DELRAN TOWNSHIP BOARD OF EDUCATION
Additions and Renovations to Delran High School and
Renovations to Delran Middle School
Addendum #1
January 3, 2019

Bid Package Clarification and Changes

CSK-1

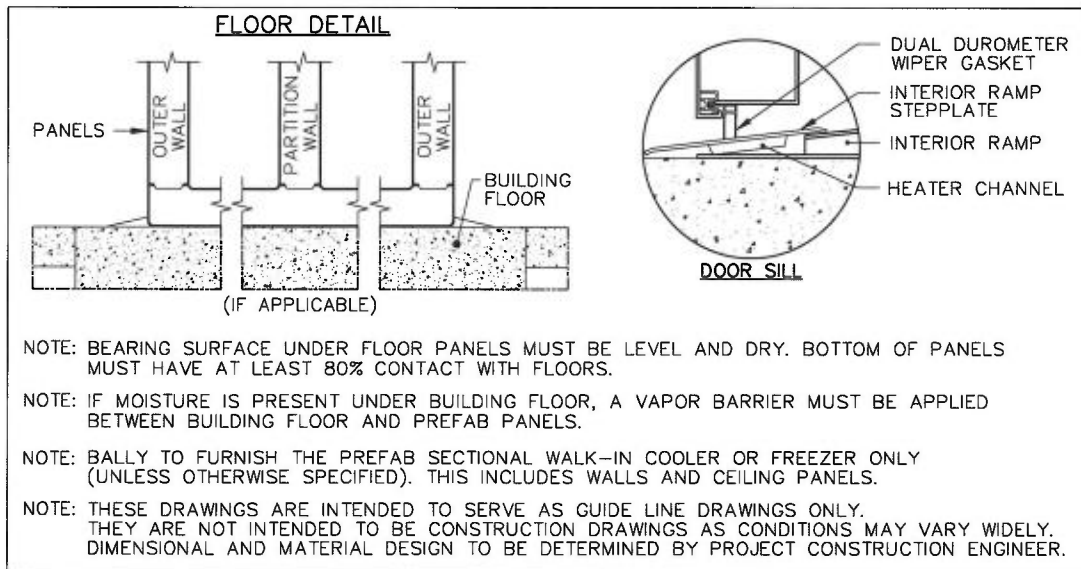
9. Refer to the **attached Sketches CSK-1 & CSK-2** as a design base for walk-in cooler at the Middle School. Provide all items noted within these sketches including heat trace as required. (2 Sketches)
